SUNDRY NOTICES AND REPORTS ON WELLS

Topacio Federal 28 Com No. 1

**Topacio Federal 28 Com No. 1
30-025-34522
Cimarex Energy Co. of Colorado
August 3, 2009
Conditions of Approval**

Proposed Hz Delaware RC

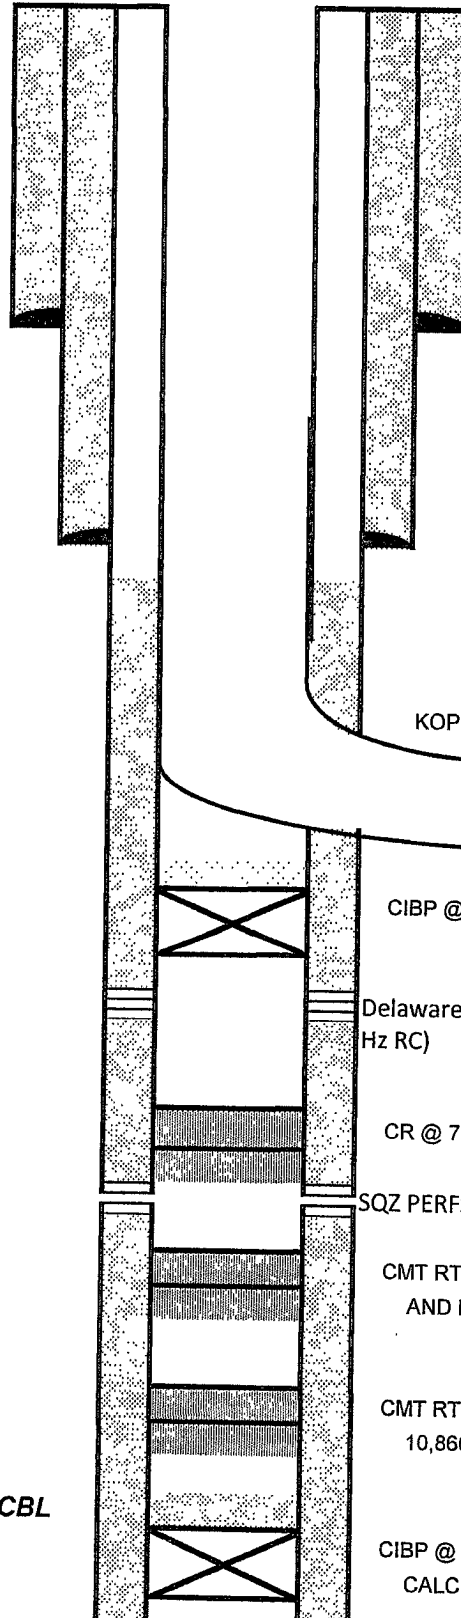
- 4. 3M BOP required and is to be tested prior to setting CIBP at 7455'.**
- 5. Plugs at top of Wolfcamp and Bone Spring formations should already be set prior to starting the horizontal drilling.**

- 6. When the well is plugged, cement will be placed on top of the CIBP at 7455'.**
- 7. No mud weight was listed, used a 9.0 ppg mud.**
- 8. Operator to attempt to establish an injection rate down the 5-1/2" by 8-5/8" annulus. If a rate can be established, operator will do a Bradenhead squeeze. A CBL will be required to determine the results of the Bradenhead squeeze.**
